Prepared for Samsung C&T Renewable Energy Australia

Amendment Report

South Coree Battery Energy Storage System

Project Number: 251103

Figure A-1 Concept intersection design for the Riverina Highway and Canalla/Martenellis Roads

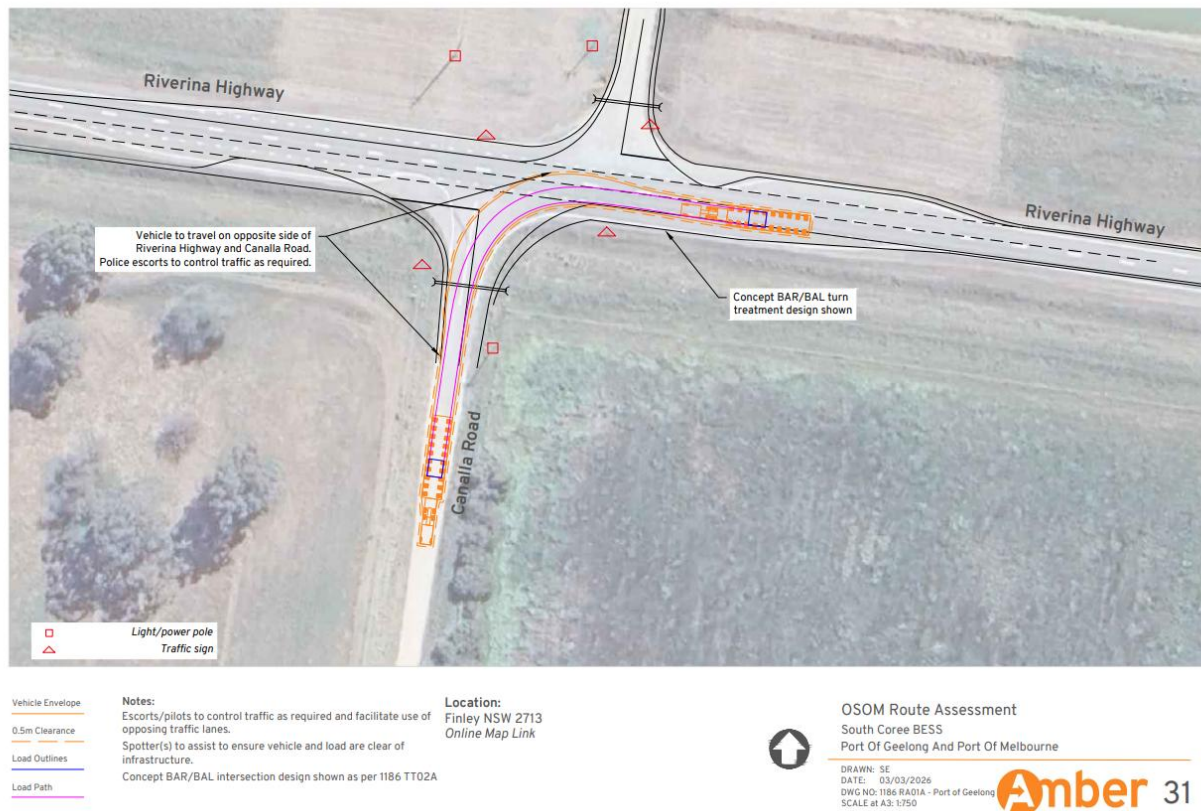
“ The strategic concept designs for the intersection of Riverina Highway/Canalla Road will need to be revised if a higher-order intersection treatment, beyond what is currently proposed (BAR/BAL), is warranted based on the revised turn-warrant assessment or provide alternative mitigation measures (i.e shuttle bus etc) to ensure that the project construction traffic volumes for the peak of construction can comply with the BAR/BAL intersection treatment”

An upgraded BAR/BAL concept design has been provided allowing the B-Double design vehicle to store to undertake a right turn allowing other road users to navigate around in the left lane. Consideration of the Martenellis Road has also been considered as part of the design. The BAR/BAL design demonstrates that intended road users of each local road can safely enter/exit the state road network. This is presented in Appendix E of the updated TIA, and detailed below in Figure A-1.

In response, the Applicant has committed to an upgraded BAR/BAL concept design.
